HISTORIC AND DESIGN REVIEW COMMISSION

HDRC CASE NO: 2016-065
ADDRESS: 133 DEVINE ST
LEGAL DESCRIPTION: NCB 723 BLK 5 LOT S 110 FT OF 21 & 22
ZONING: RM4 H HS
CITY COUNCIL DIST.: 1
DISTRICT: Lavaca Historic District
LANDMARK: House
APPLICANT: Kimberlee Lorenz/ReVamp Design Build
OWNER: Frederic Allegrini Cherise Rohr
TYPE OF WORK: Addition
REQUEST:

The applicant is requesting a Certificate of Appropriateness for approval to construct a two story rear addition to the structure at 133 Devine. The applicant has proposed materials to include wood windows, wood siding and a standing seam metal roof.

PROPOSED ROOF PLAN

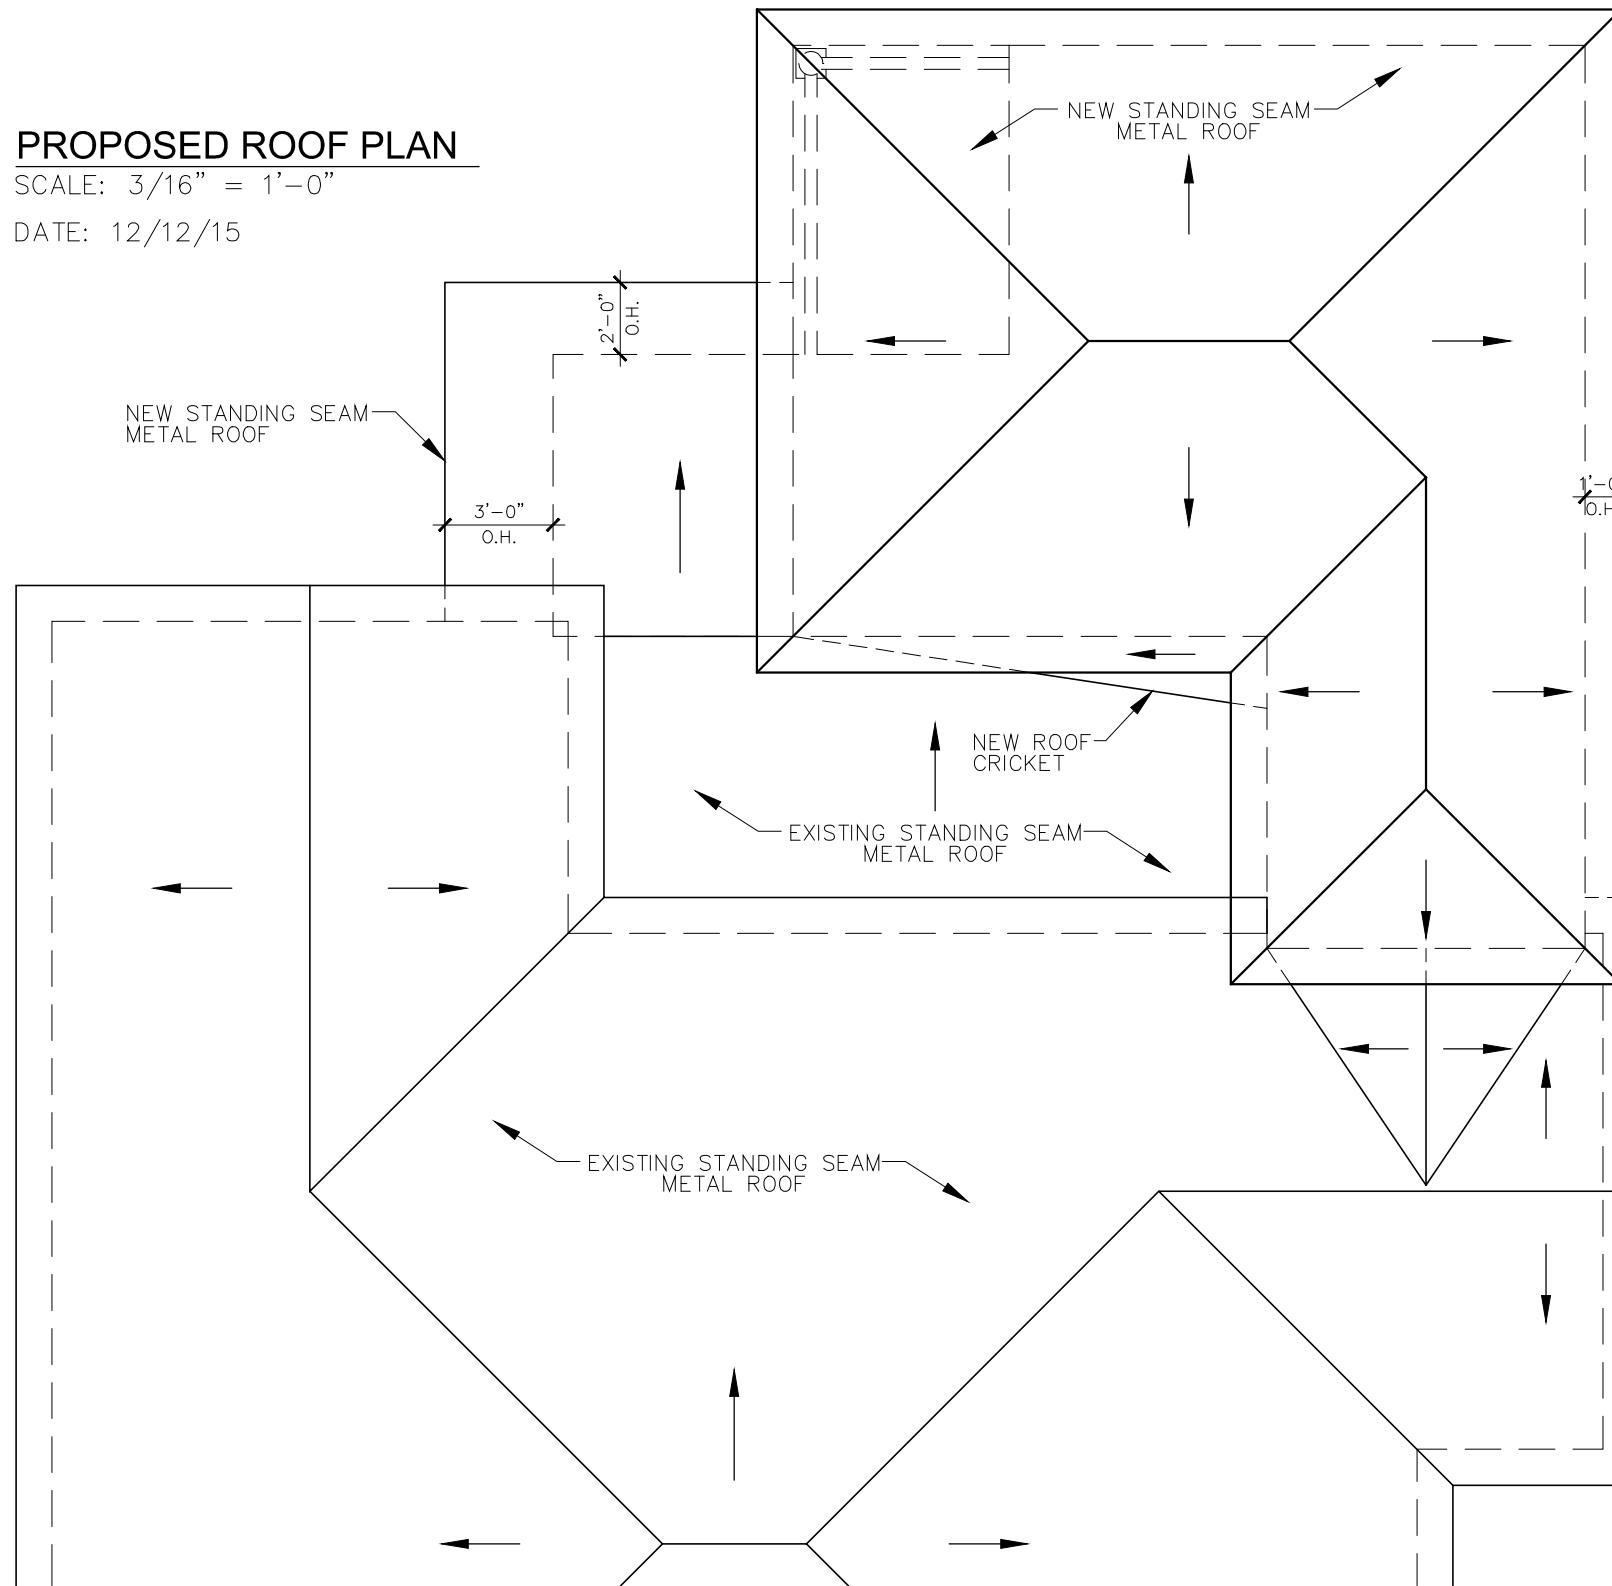
- d. The applicant has proposed for the addition to include a series of hipped roofs. Staff finds that a lower pitched roof consisting of gables will not only reduce the overall height of the addition, but also further relate it to the original structure's. Overall height of the proposed addition's ridgeline is greater than that of the original structures. Staff finds that a ridgeline that is subordinate to that of the original structure's is appropriate and consistent with the Guidelines for Additions 1.B.i.

- f. Generally, the height of new additions should be consistent with the height of the existing structure. As noted in finding d, the overall height of the proposed addition is inappropriate. Staff recommends the applicant modify the proposed roof form and reduce the overall height to be consistent with the Guidelines.

At this time, staff does not recommend final approval. Staff find that the applicant's proposed materials and overall footprint are appropriate, however, staff does not find the proposed roof form nor overall height of the addition appropriate. Staff finds that with a modified roof form, the overall height of the addition as well as its massing may decrease and become appropriate.
